No. 95-2

V6 & V8 Replacement Cylinder Heads

Models

Rocker Arm Part Number

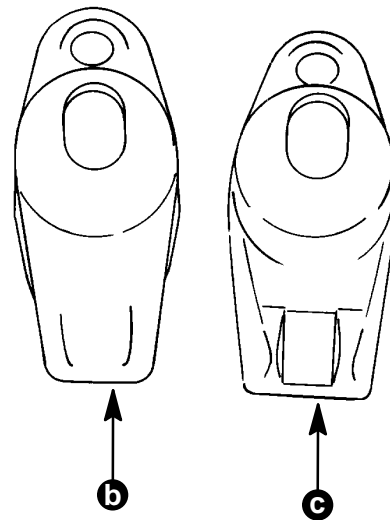
Before ordering a replacement cylinder head for any of these engines, look at the hole in the cylinder head that the push rods come through. Also look at the type of rocker arms that came off. If the rocker arms are not the "Self Aligning" type rocker arms, all new rocker arms must be ordered also. All replacement heads have a hole for the push rod. If "Self Aligning" type of rocker arms are not used with these new heads, the rocker arm will not stay on the push rod.

- a - Push Rod Hole: Slot=Keeps Push Rod Aligned.
Drilled Hole=Must Use "Self Aligning" Rocker Arm.
- b - "Non Self Aligning" Rocker Arm.
- c - "Self Aligning" Rocker Arm.
